Re: S/D 88-108 - MEDITERRANEAN PLAZA 2ND ADDITION

At the regular meeting of the Subdivision Committee of the Metropolitan Area Planning Commission on Thursday, November 15, 1990, the above captioned plat was considered. The action of the Committee was to recommend that this plat be approved subject to:

STAFF REPORT  
(Revised Final Plat)  
(Final Plat Approved 6/1/89;  
Preliminary Plat approved 1/12/89)

CASE NUMBER: S/D 88-108 - MEDITERRANEAN PLAZA 2ND

MEDITERRANEAN PLAZA 2ND

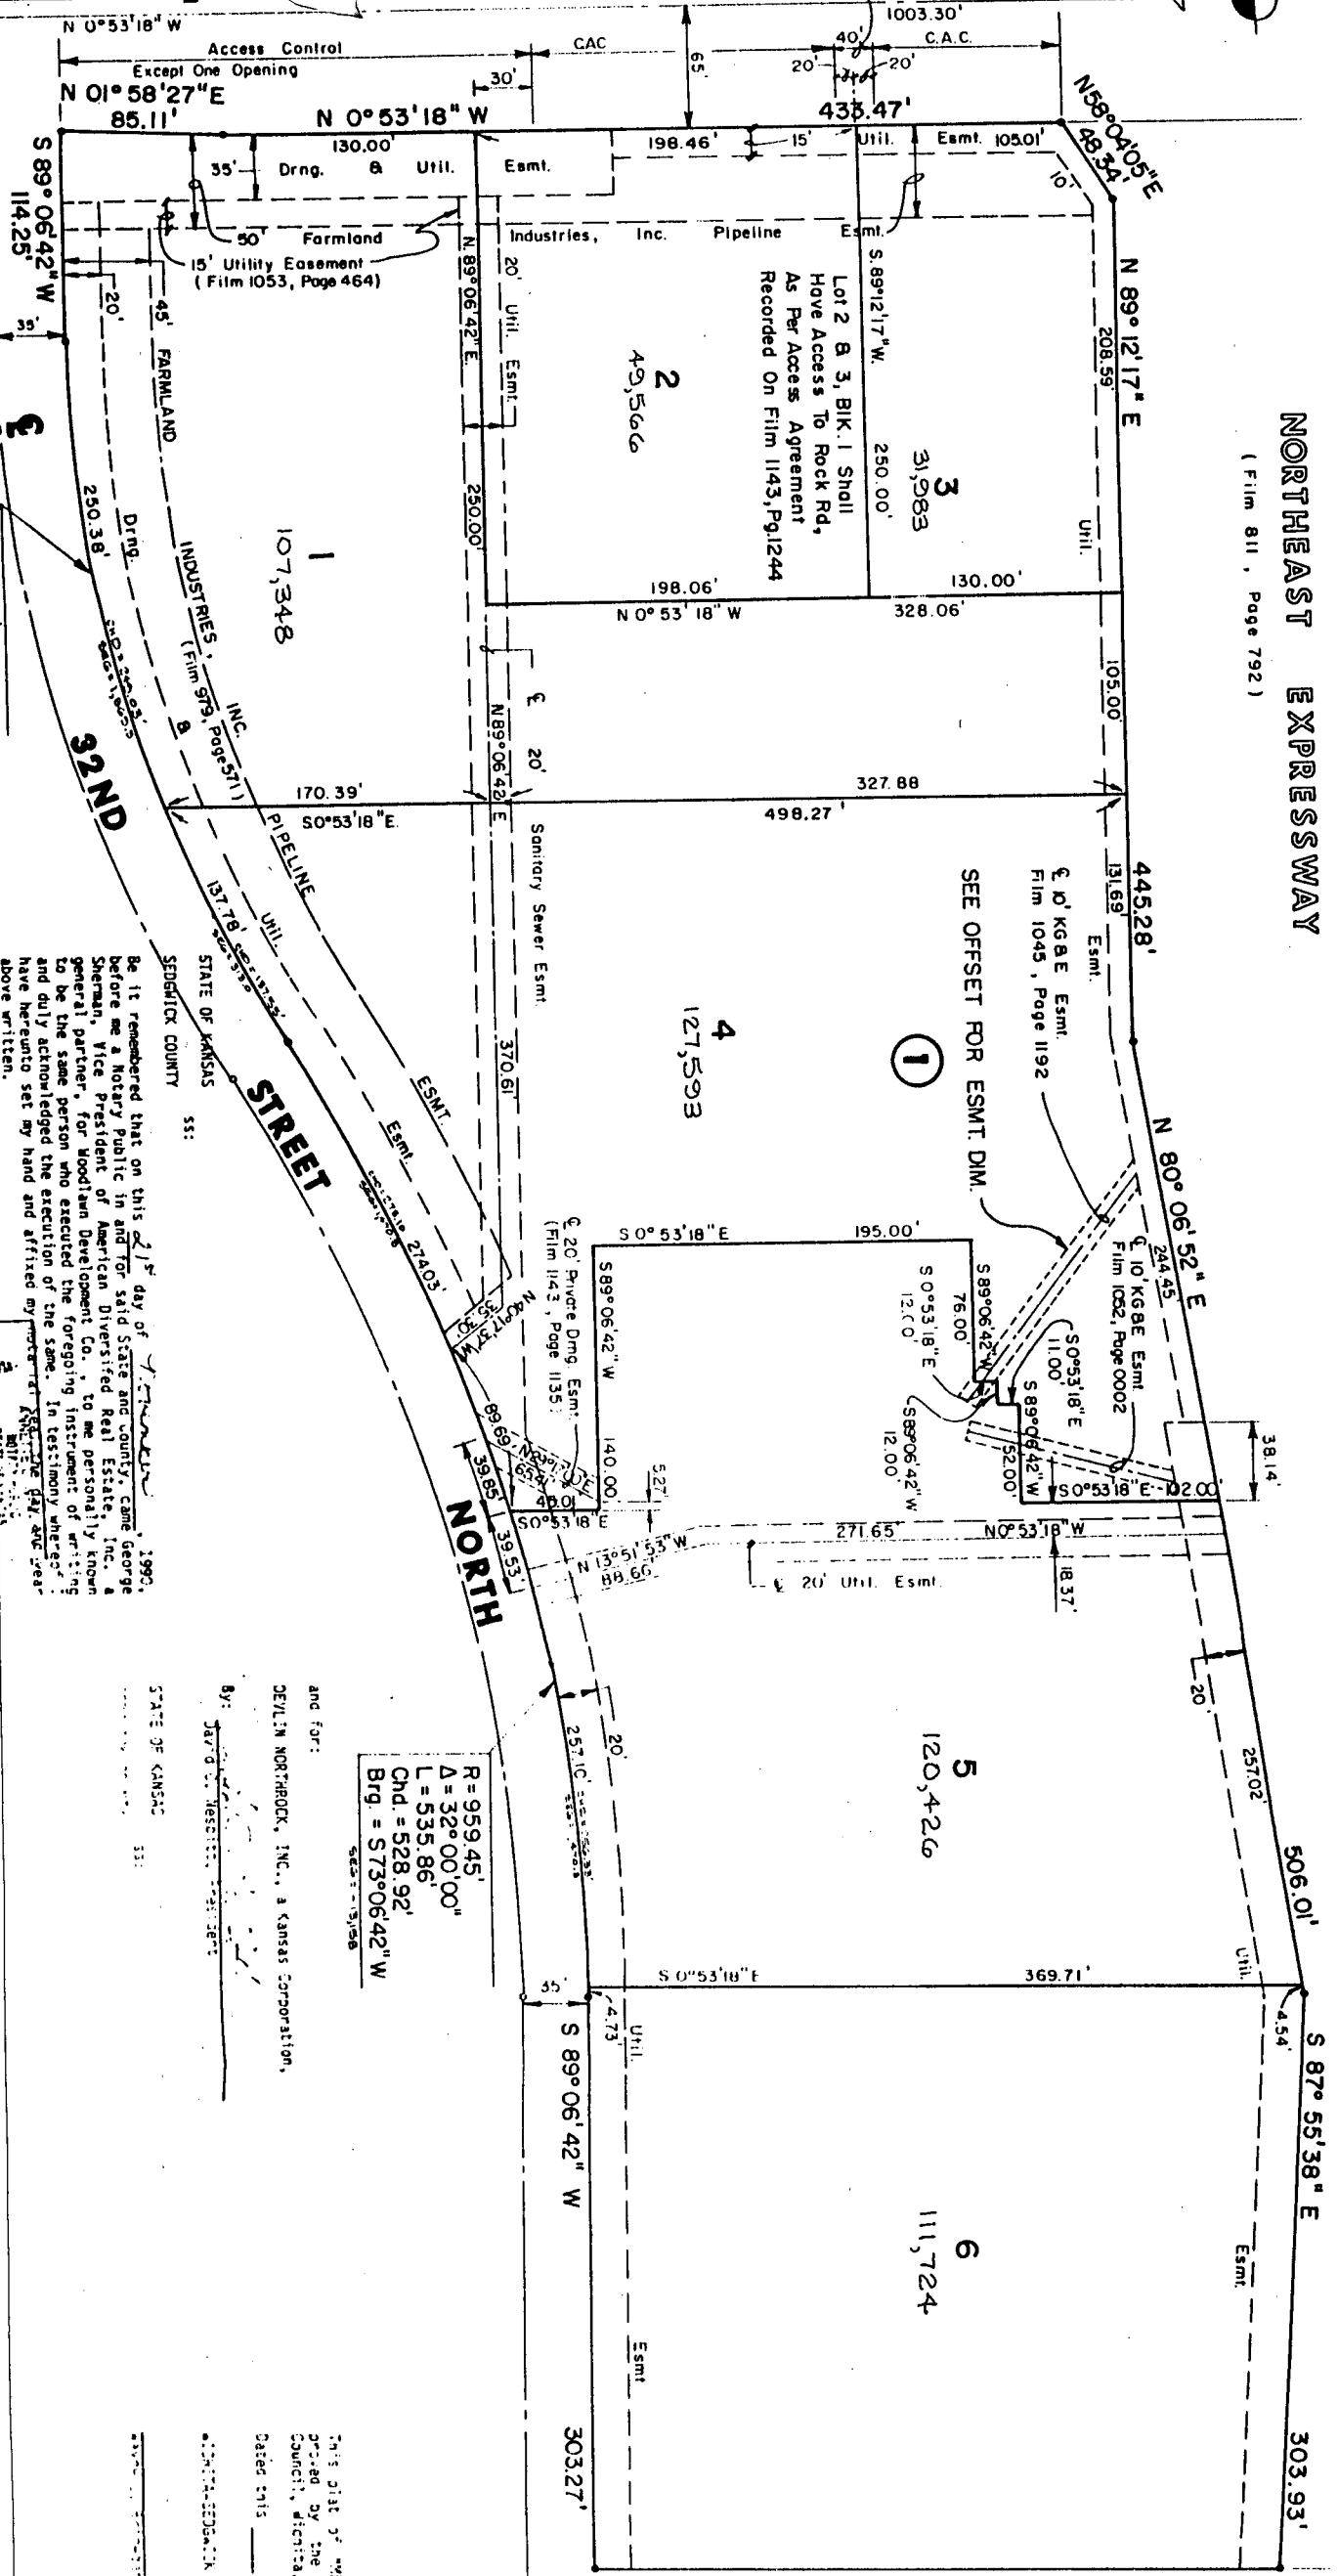
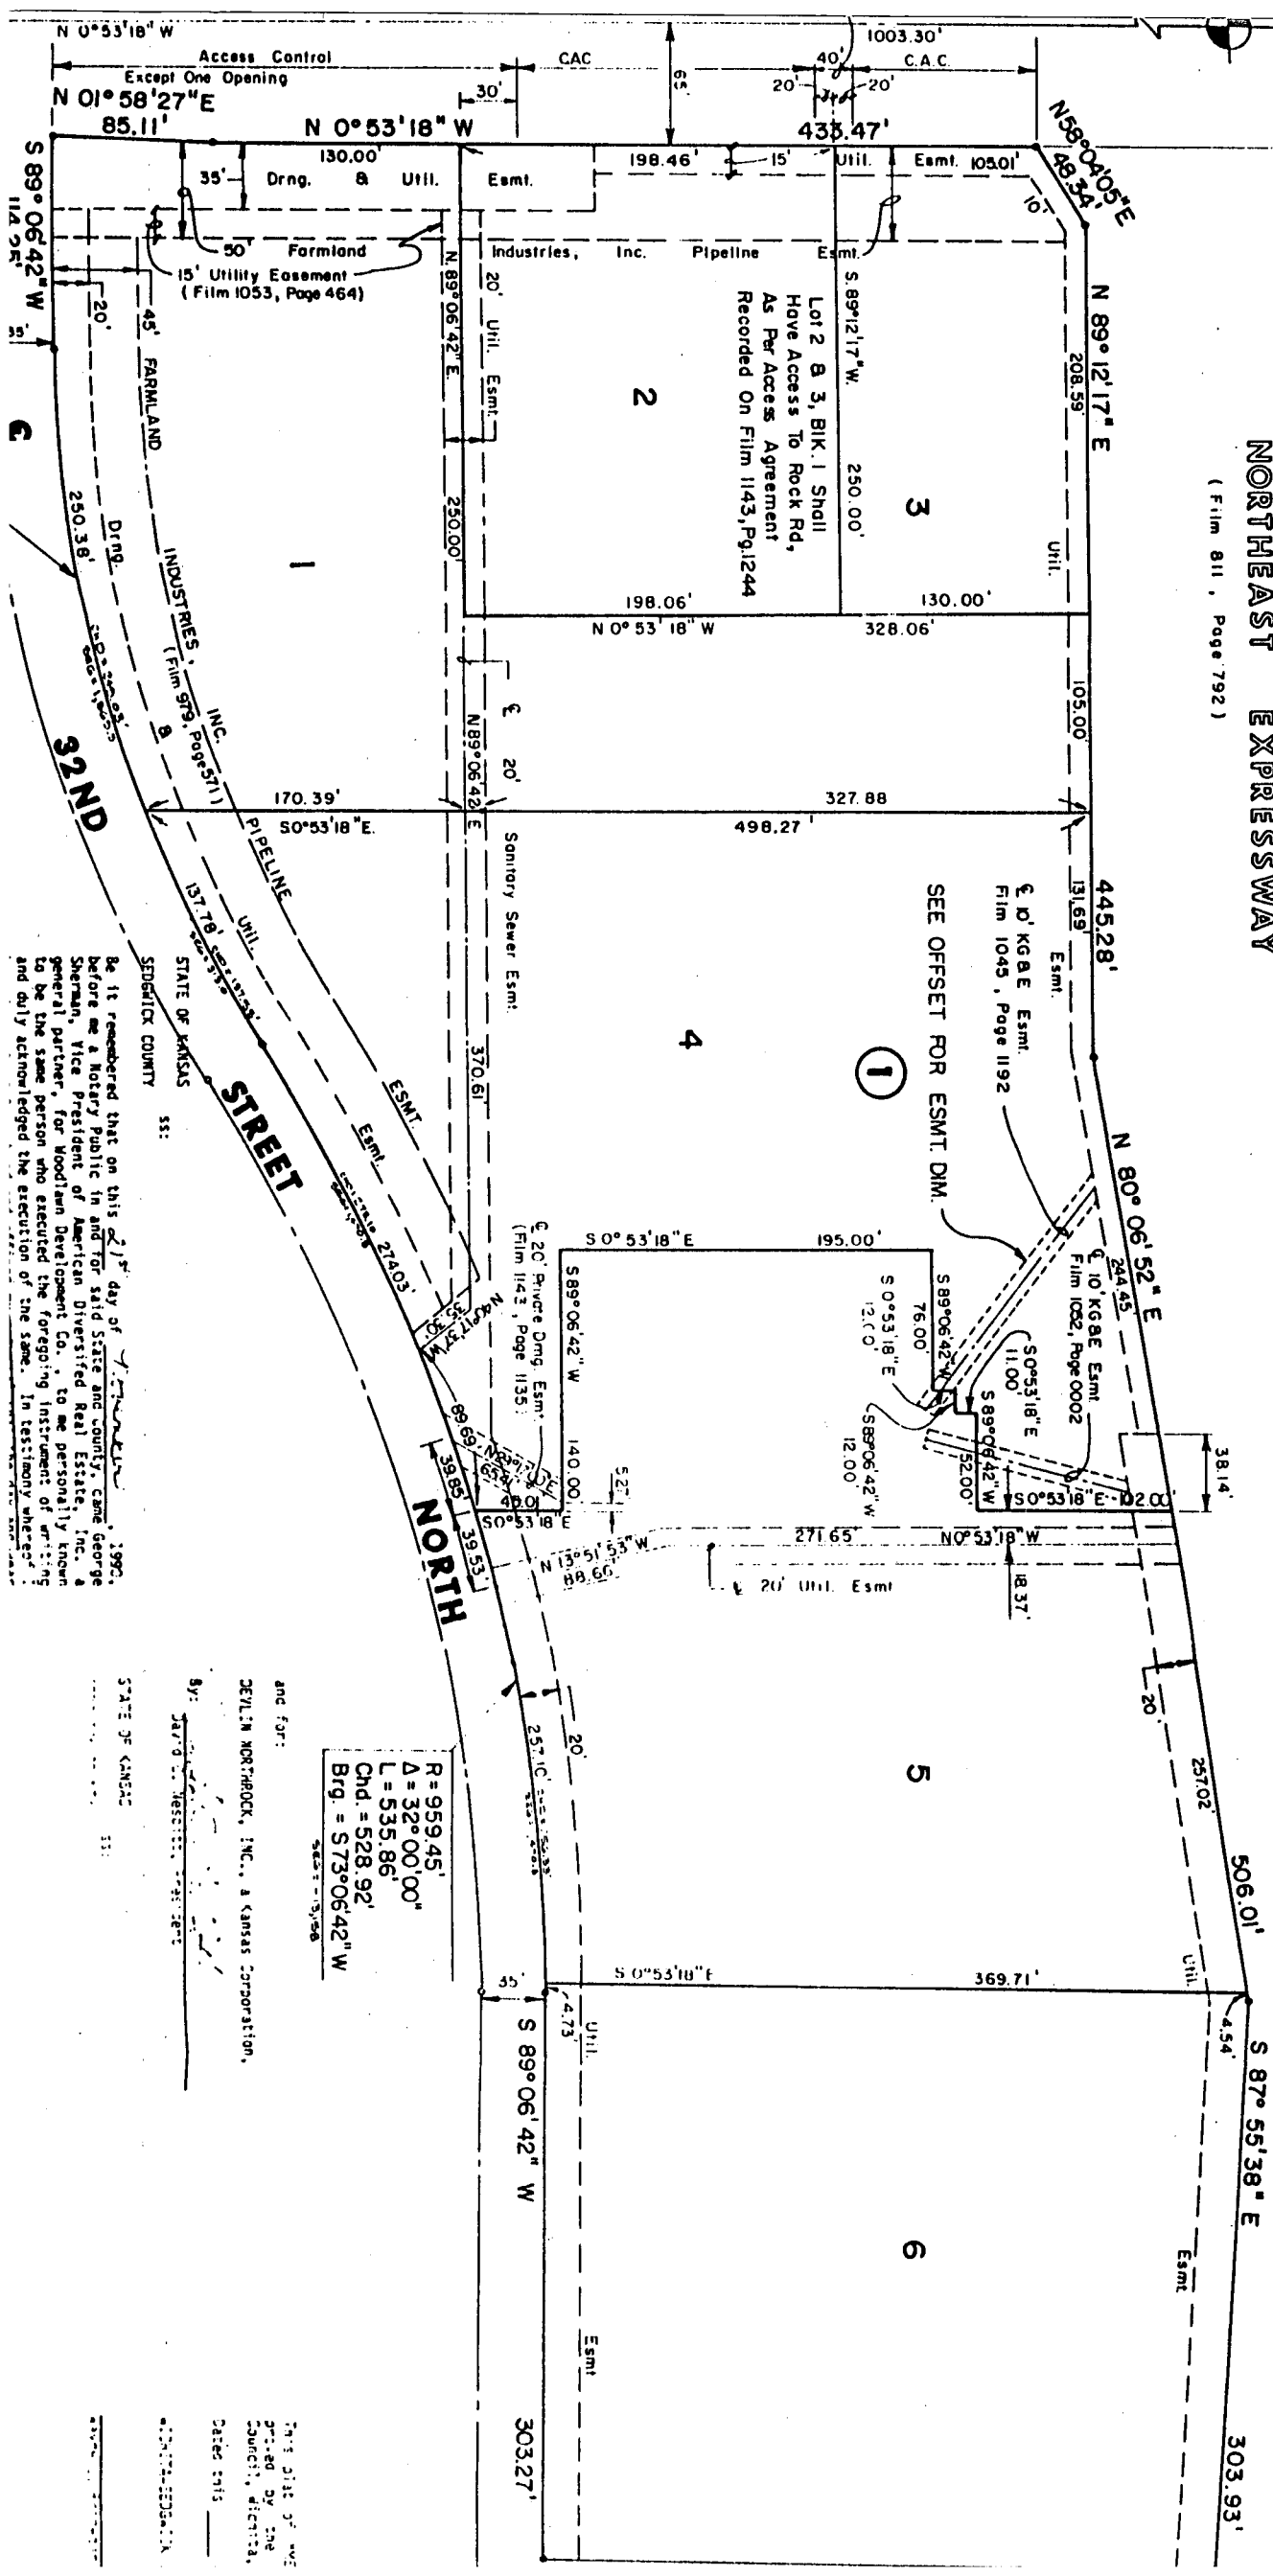
- C. On the face of the plat, the word "Complete" shall be deleted from the access control to lots 1, 2, and 3, since openings are being provided from these lots to Rock Road.

- D. The plattor's text shall also be amended in regard to the complete access control being established across the north line of this plat. Since no "Reserve A" is shown on this plat, reference to it should be deleted. Both the plattor's text and face of the plat can reference the proposed North East Expressway to the north of the site, or the text can simply note that complete access control is being dedicated across this site's (lots) north line.

- E. In order to better locate the K.G. & E. easements on lot 2, the drainage easement on lots 4 and 5 and the position where the sanitary sewer easement crosses lot 1 and 4's lot line, additional dimensions shall be provided from appropriate lot corners to these easements.

- J. A note shall be placed on the face of the final plat tracing which indicates that building setbacks between lots are per requirements of C.U.P.-188. The plat's text shall also note these requirements. The present reference to a C.U.P. on the final plat is inadequate.

- K. The City Council signature block shall be amended to indicate that the plat is accepted by the City "Council" not "Commission."
- L. The applicant shall install or guarantee the installation of all utilities and facilities which are applicable and described in Article 8 of the MAPC Subdivision Regulations.
